ADDENDUM NO. 2

DATE: February 24, 2023

RE: Dickinson Park Sports Fields Renovations
Project No.: 21-1558

Drawings: (all revisions have been clouded and tagged with a delta-2)

4 ROOF PLAN
S1.0 3/8" = 1'-0"

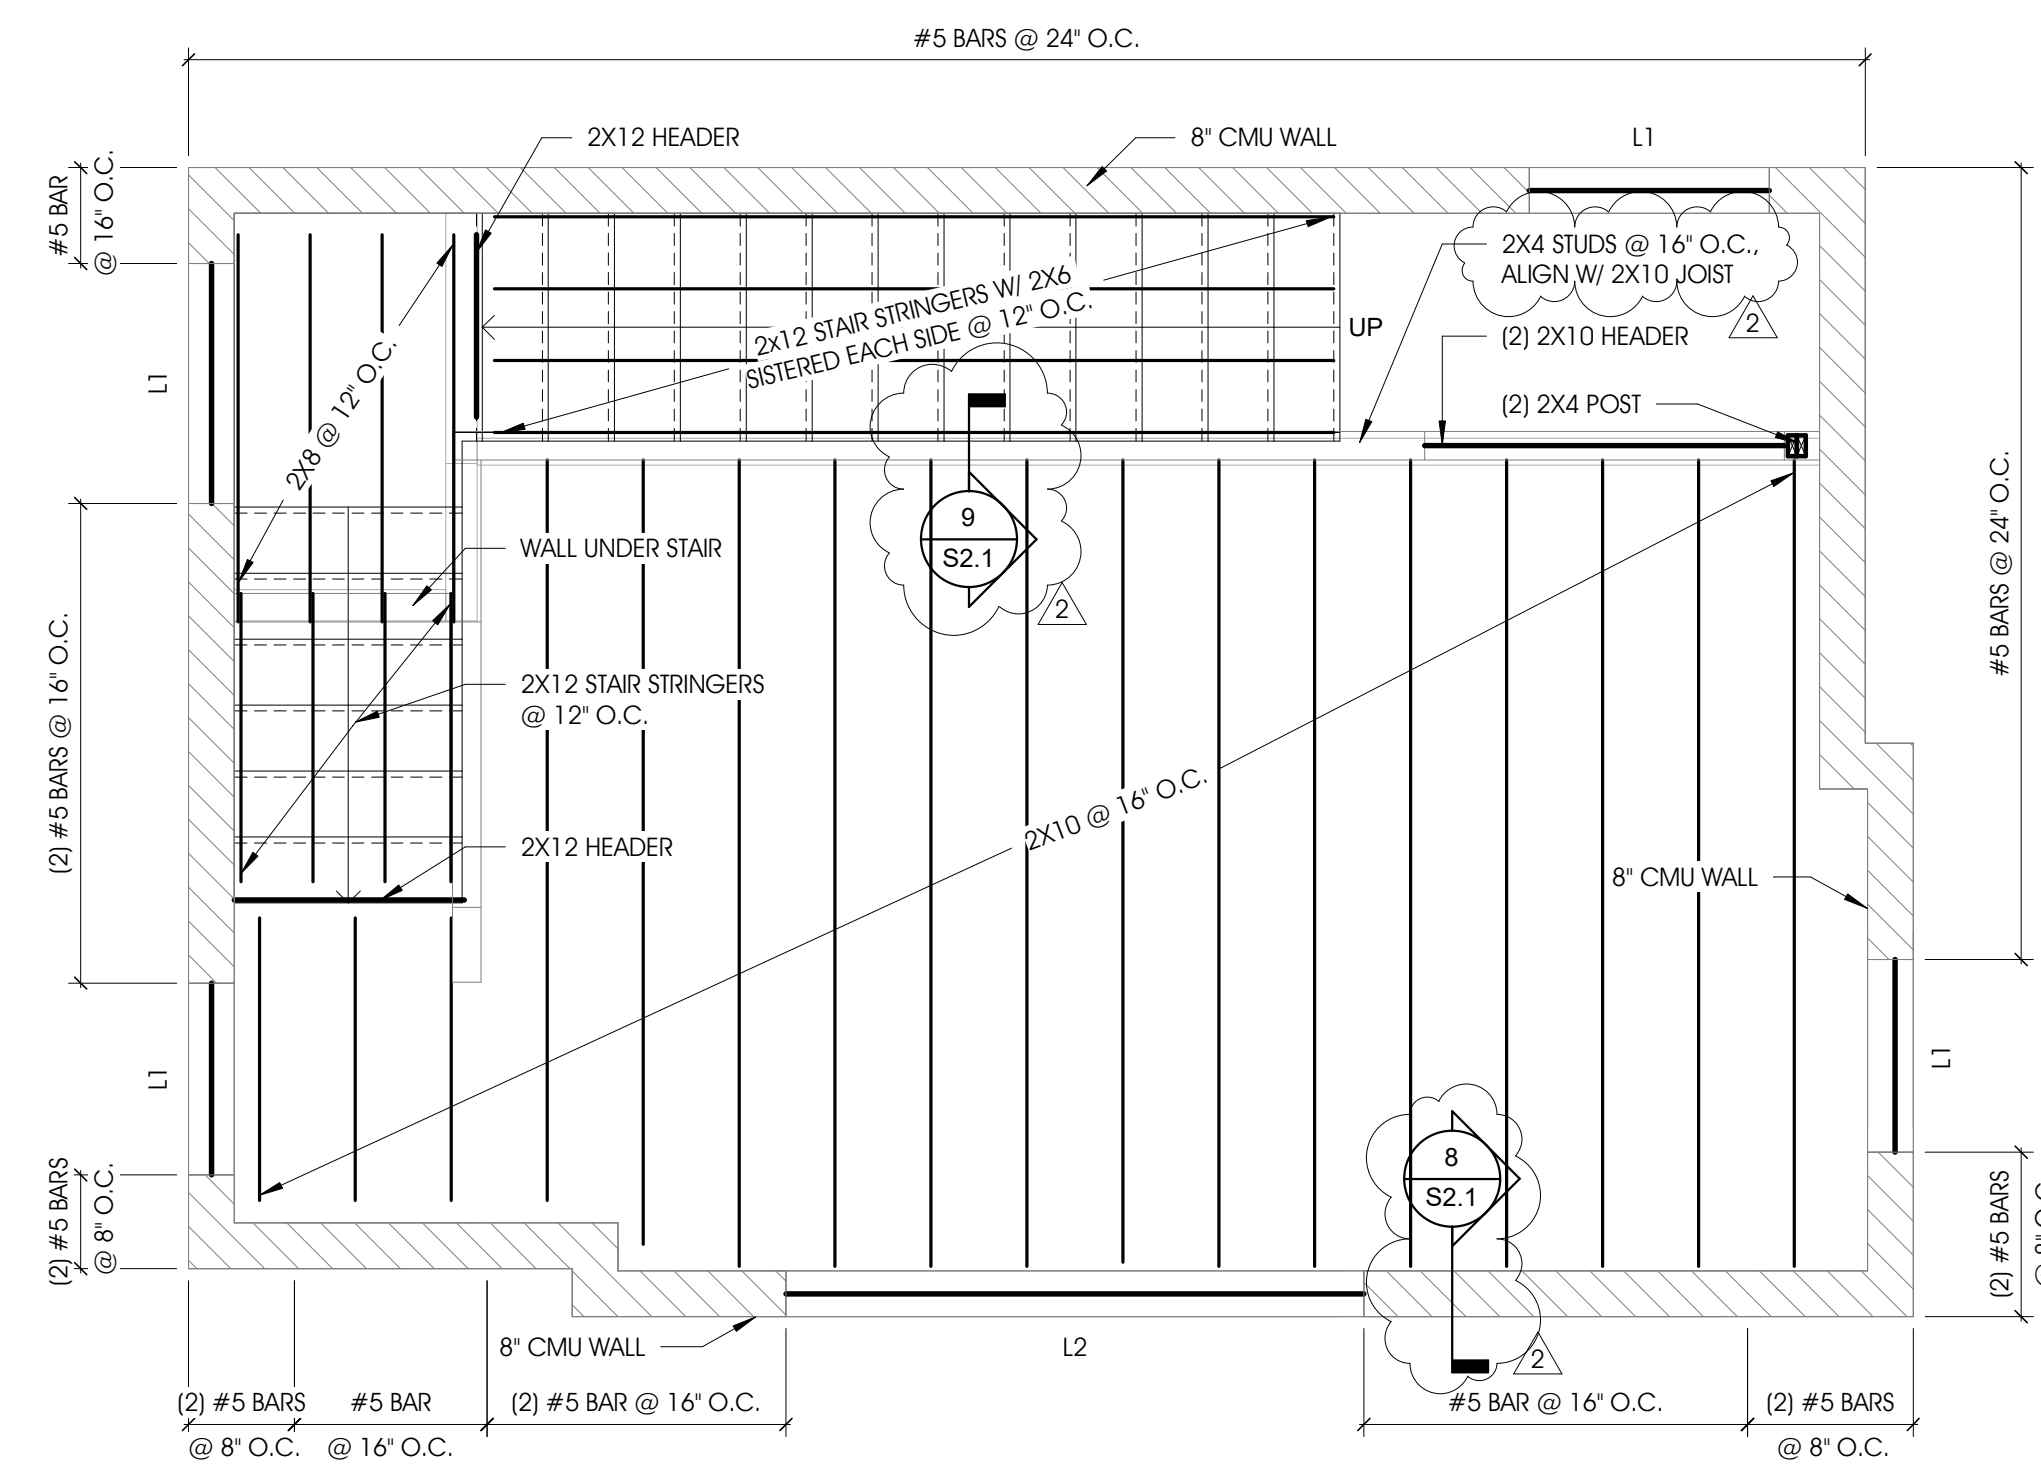
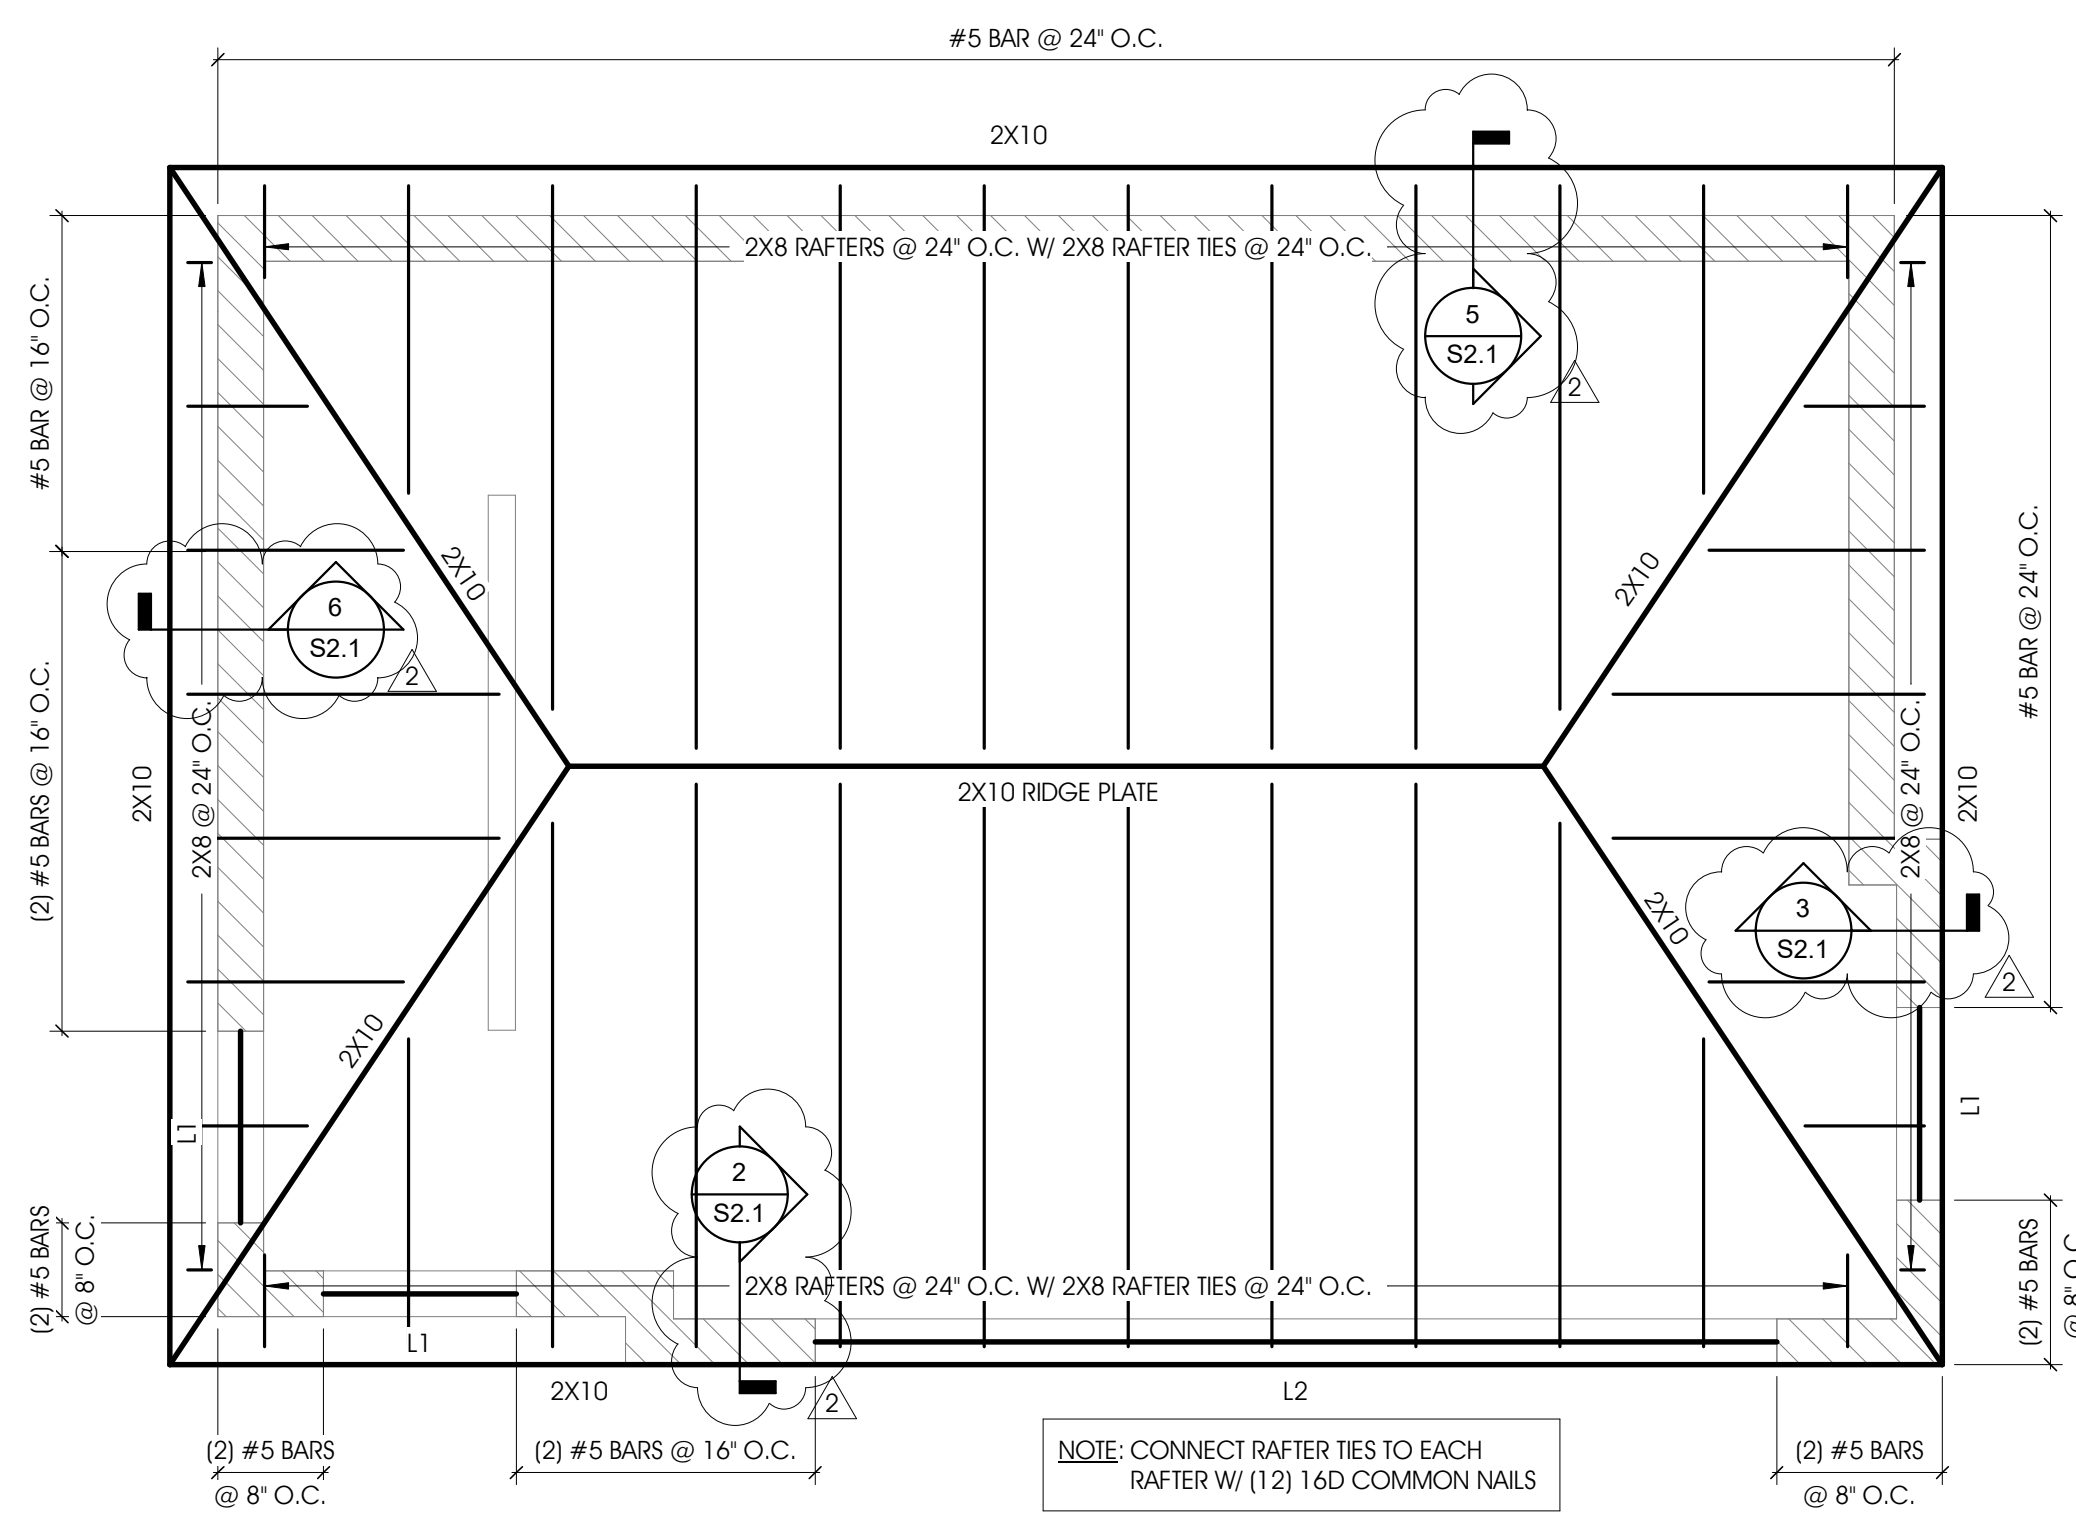
- a. Moved Typical Foundation Detail, Typical Lintel Bearing Detail, and Typical Thickened Slab Detail to Sheet S2.1.
 - b. Added Ceiling Plan.
 - c. Added various Detail-Section tags and notes (see revision bubbles).

- d. Added Lintel Sections detail drawings.
 - e. Minor revisions to General Notes C and F.
13. Alternate 1, Sheet S2.1
- a. Added Sheet S2.1; previously omitted by error
